ADDENDUM #1

Project No.:	16-0023	Date:	January 4, 2019
Project:	Renovations for Community Education Center Portage Public Schools Kalamazoo County, Michigan	A/E Firm:	C2AE
Owner:	Portage Public Schools 8135 South Westnedge Ave. Portage, MI 49002	Project Manager:	Thomas McKercher
		Project Architect:	Gregg Jones
		Const. Manager:	Owen-Ames-Kimball

A1.4 Refer to Sheet M-401 (reissued):

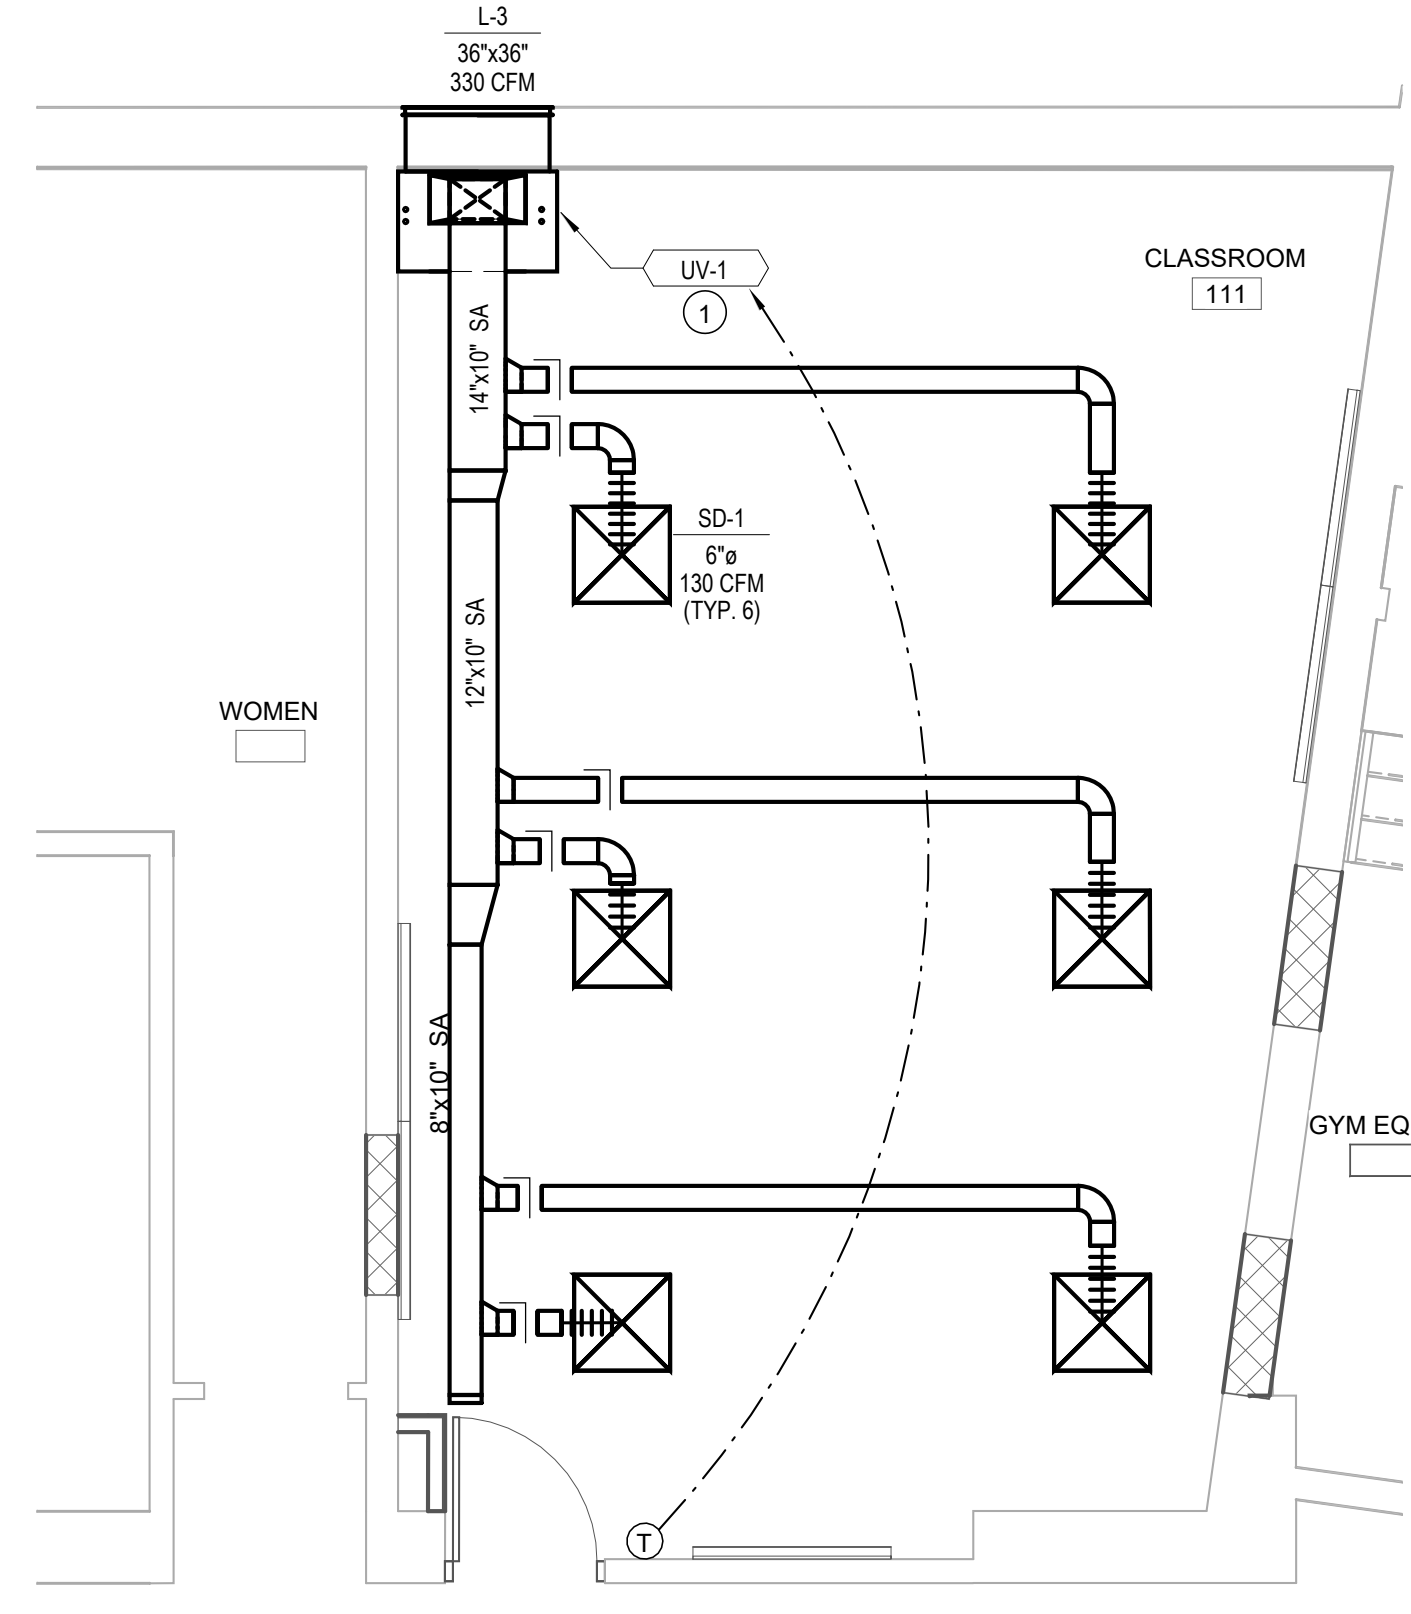
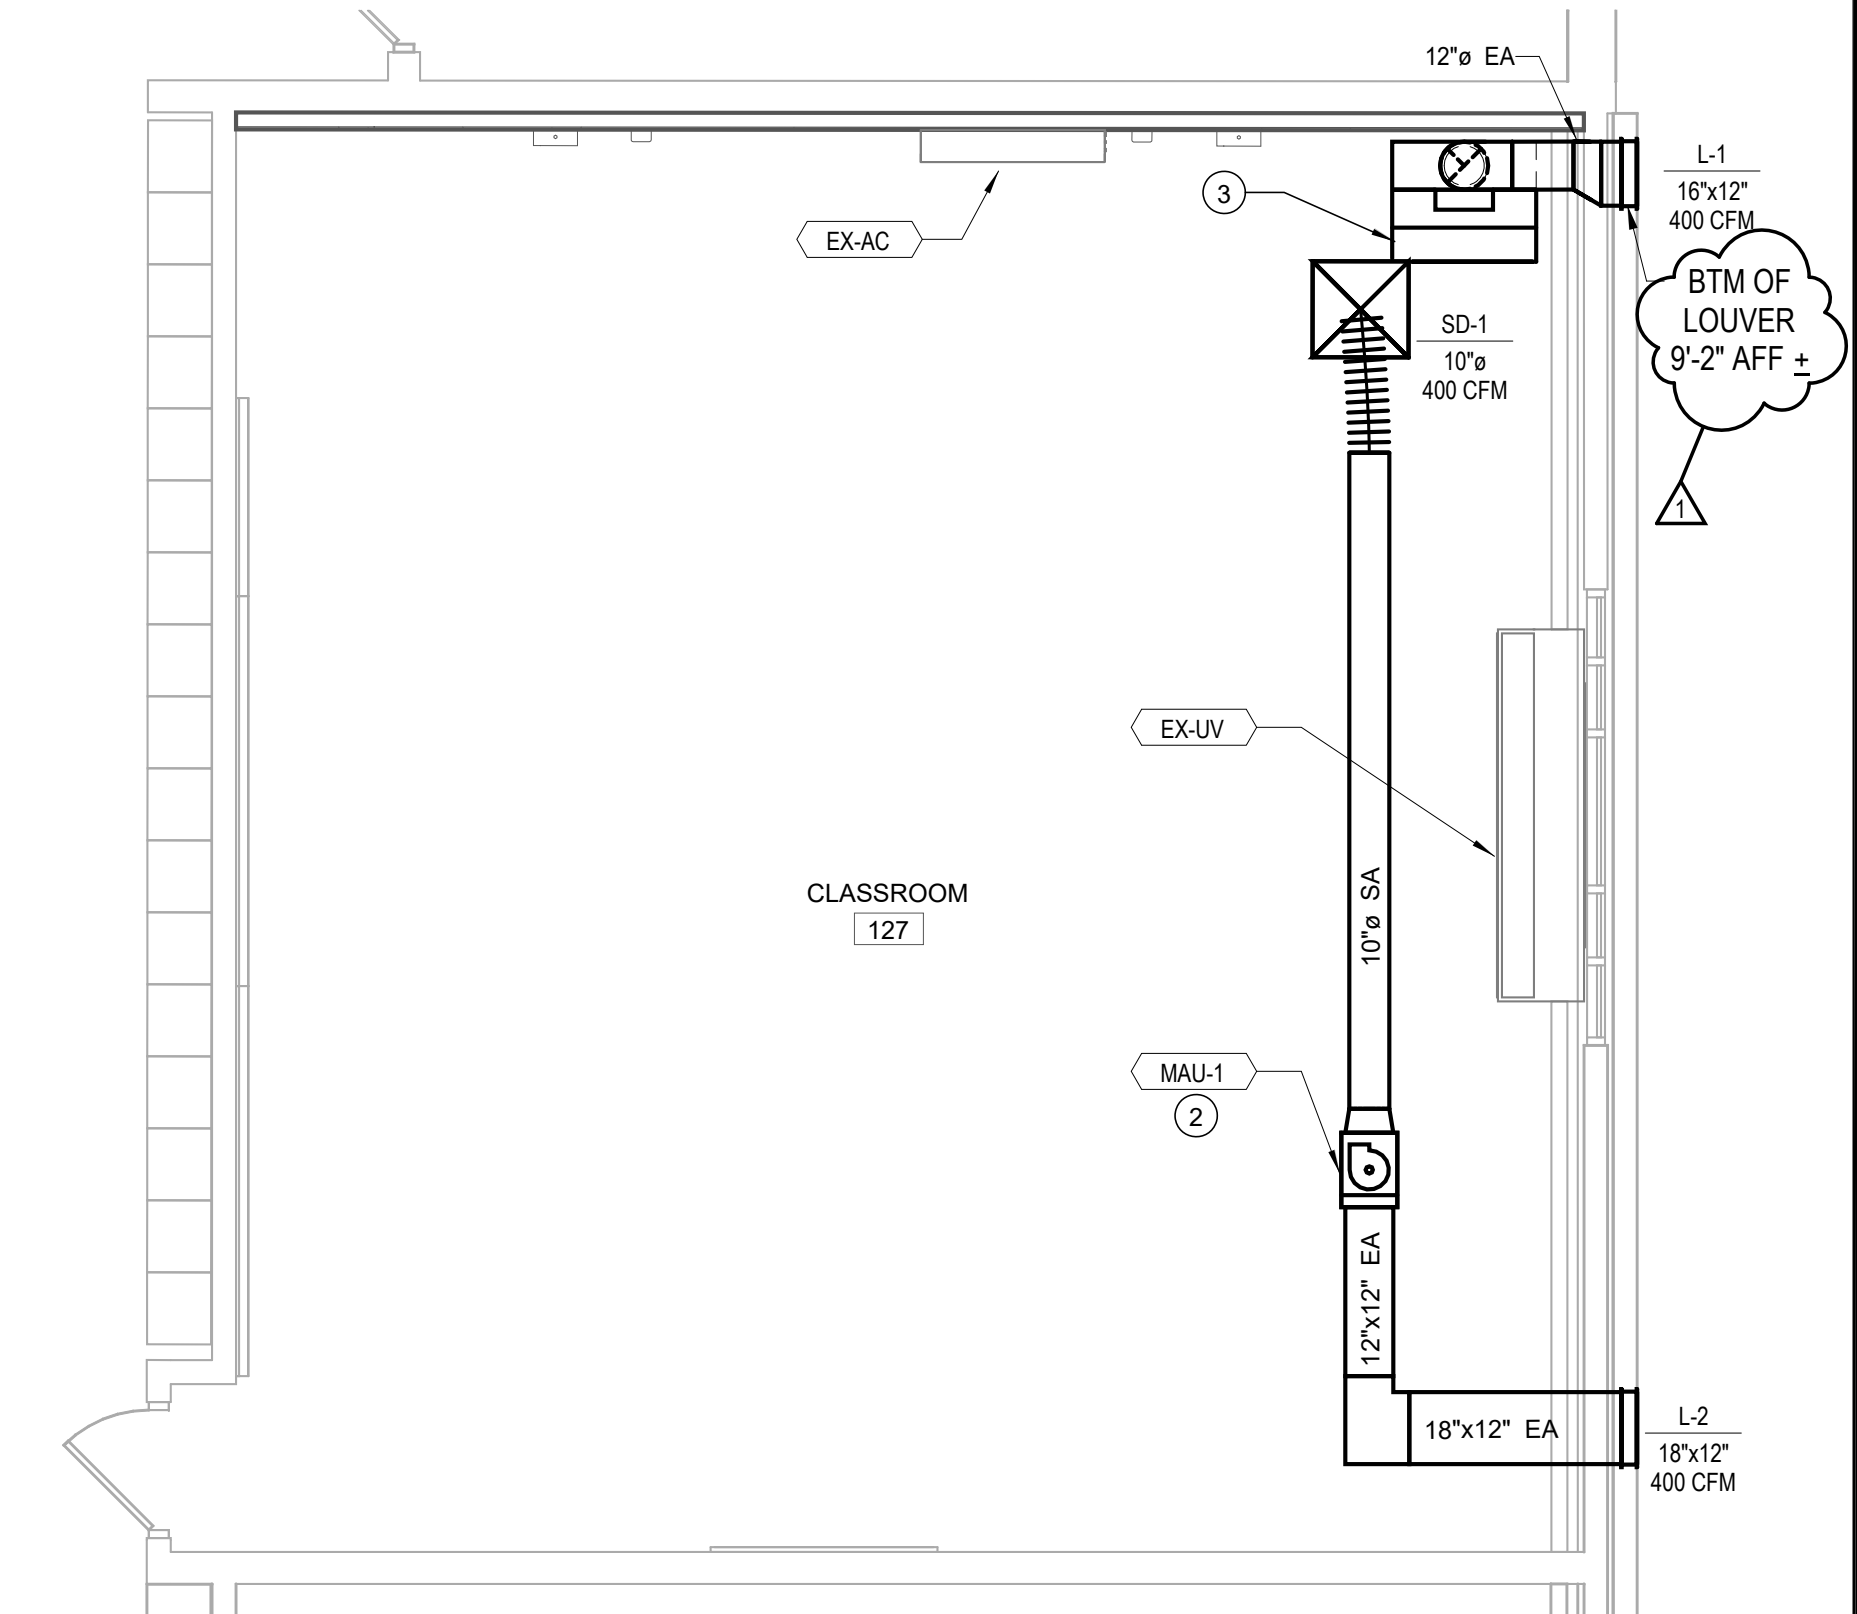
- REVISE Mechanical Keynotes 1 and 4.
- ADD elevation value for L-1.

- MECHANICAL KEYNOTES:**
- UNIT VENTILATOR MOUNTED ON FLOOR. BASED ON AREDALE MANUFACTURER FURNISHED LOUVER AND WALL SLEEVE. CONCEAL DUCTWORK FROM UNIT TO CEILING WITH MANUFACTURER FURNISHED SHEET METAL COVER. PROVIDE WITH LOW PRESSURE STEAM COIL AND BYPASS VALVE. CONNECT TO EXISTING STEAM AND CONDENSATE PIPING ABOVE CEILING.
 - WALL EQUALIZER MOUNTED WITH WALL IN TAKE WOOD SMOKE DAMPER, FILTER CASSETTE, AND 10 KW DUCT HEATER - Z08601
 - LAB HOOD EQUAL TO LABCONCO FULLY ASSEMBLED BASIC 47 UNIT, 4 FEET WIDE WITH INTEGRAL BLOWER MOTOR - 115V/1PH/60HZ
 - NOT USED.
 - EXHAUST FAN MOUNTED IN CEILING. ROUTE 6" DUCT, 50 CFM, FROM ROOM INTO SPACE ABOVE CEILING IN THE CORRIDOR. THE AIR IS NOT REQUIRED TO BE EXHAUSTED TO THE OUTDOORS.
